66-F-35
W.P. 233-65
HWY. #2
GRAND RIVER
AT PARIS

FOUNDATION INVESTIGATION REPORT

Hwy. #2 Crossing of Grand River
District #3 (Stratford)

Re: Claim on Contract 66-283
Grand River Bridge at Paris

ONTARIO DEPARTMENT OF HIGHWAYS MATERIALS and TESTING DIVISION	GRAND RIVER BRIDGE AT HWY. 5 PIER NO 4 FOOTING (PARIS - ONTARIO)	
	WP 233-65	CONTRACT 66-283
DATE JUNE 26, 1967	APPROVED 	DRAWING NO. 66-F-35 B

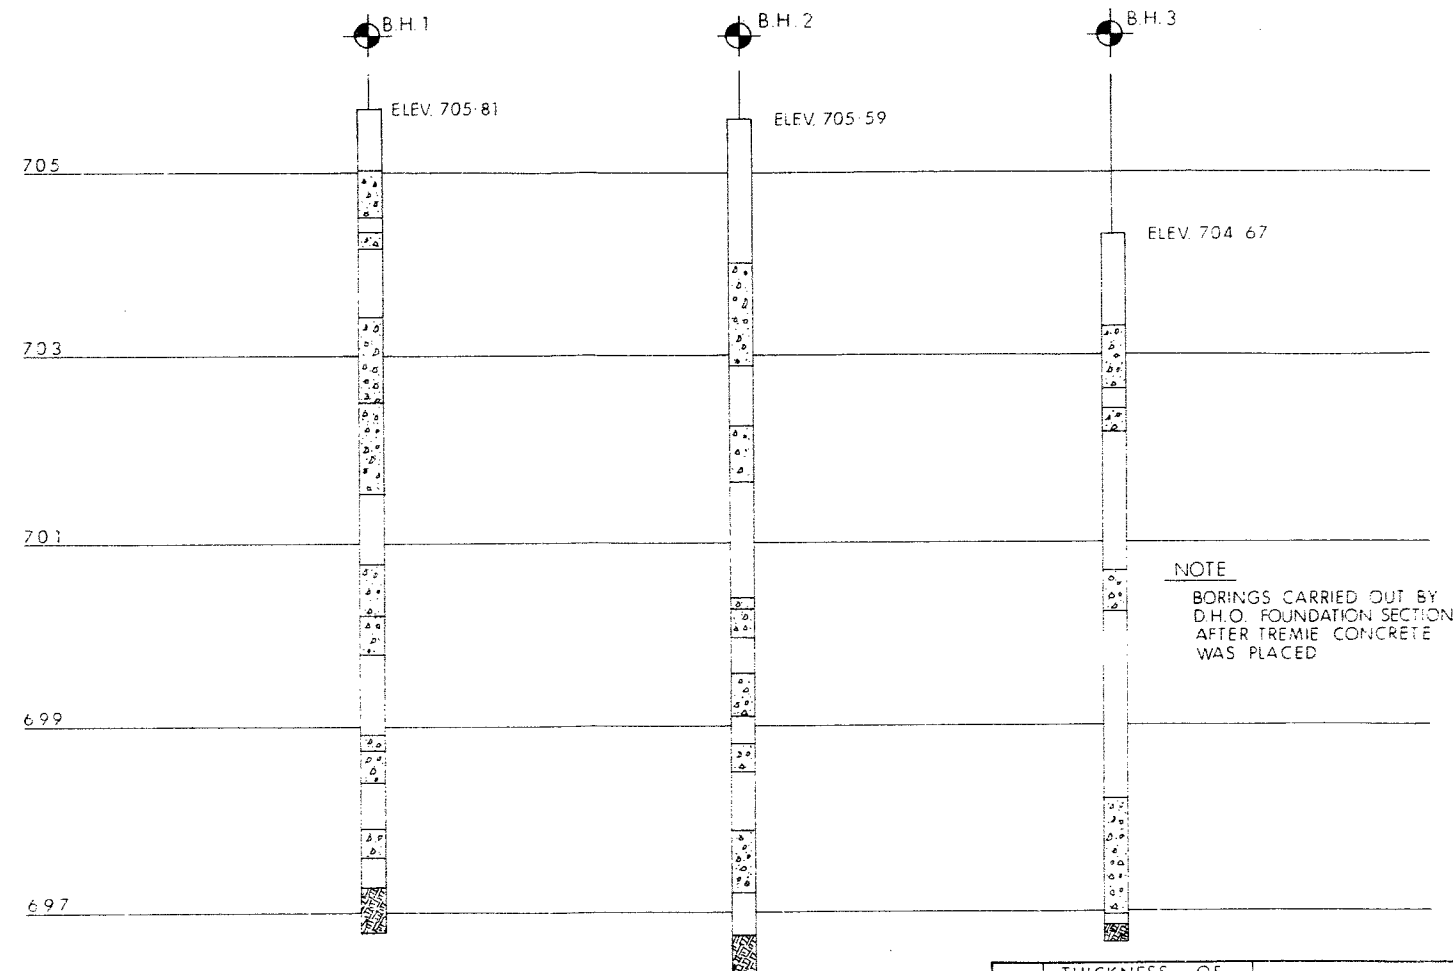
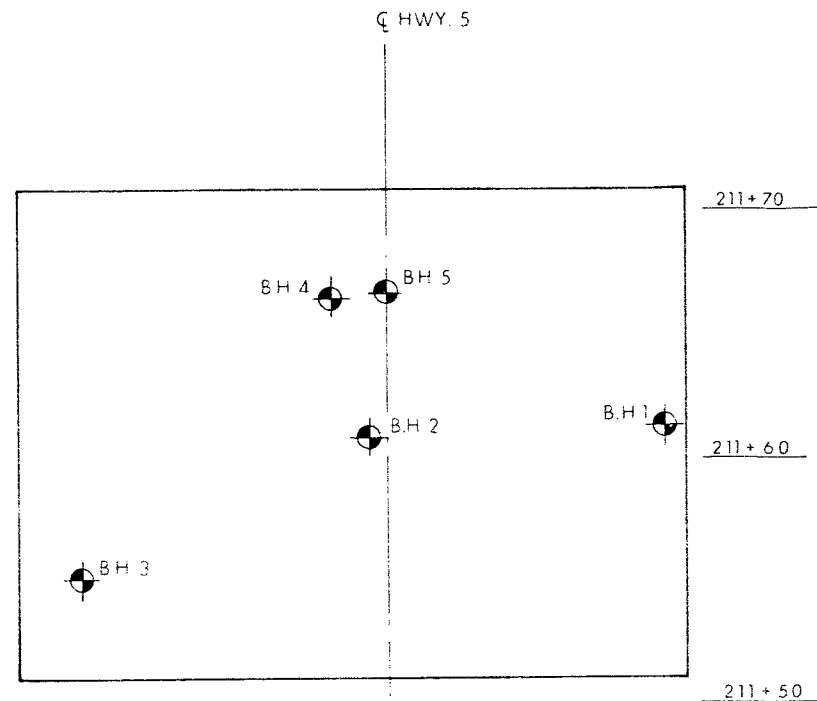
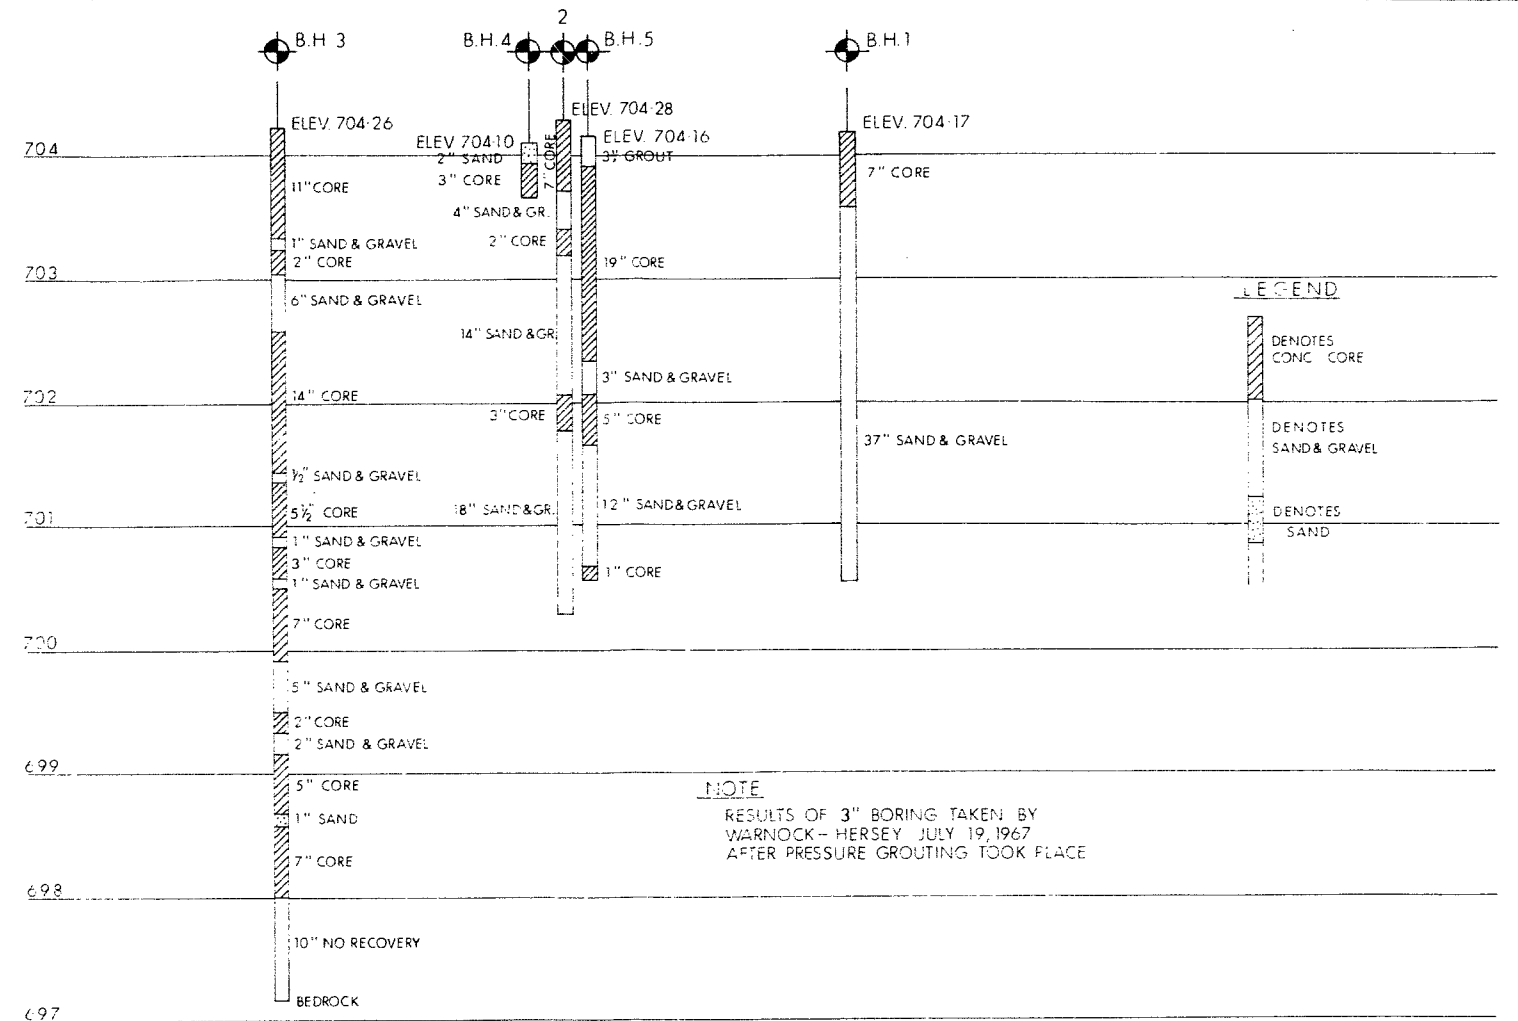
The dewatering of the excavation was indeed impractical because of the very poor and incompetent way the steel sheet cofferdam was built.

The Contractor had driven very light sheeting into the ground which, below elev. 713, contains occasional boulders (as stated in the Foundation Report dated June 17, 1966, B.H. 1) and the sheet piling was therefore bent, buckled and in places, hung up at higher elevations and not driven to the required depth. Water was pouring into the excavation from all sides. Due to the fact that sound rock was not yet reached, water naturally entered the excavation also through the broken and fissured bedrock at the bottom.

We would, however, also like to comment on a few statements made by the Contractor in Claim No. 1 - Dewatering Pier No. 4.

The foregoing statement is not correct because the ground elevation at B.H. 1 was 728.8 and the groundwater level indicated at elev. 715.5 - i.e., 13.3 ft. below ground level. An artesian condition would imply that the groundwater or piezometric level is, or can arise above ground, which was not the case here.

The above statement is also not correct because the water-bearing stratum at this location is the till layer (elev. 712.9 to 704.0) and the underlying zone of very extensively weathered bedrock (elev. 704.0 to 696.8). It was to be expected to encounter variable, but considerable inflow of water from all sides, into the excavation until sound bedrock was reached. Consequently, the Contractor's statement on page 2, which reads: "We believe that the D.H.O. were totally unaware of this aquifer occurring at elevation 702 to 700.5, although fairly extensive foundation investigations were undertaken." - does in no way describe our understanding of the problem.

The undersigned realized, while at the site, that in order to dewater the excavation, a new row of heavier steel sheet piles would have to be driven outside and around the existing one. The undersigned believed this to be the right way of completing the job in the manner it was bid on and awarded - i.e., to excavate to the required elevation (Min. 695.5') in the sound rock and pour the footings in the dry.
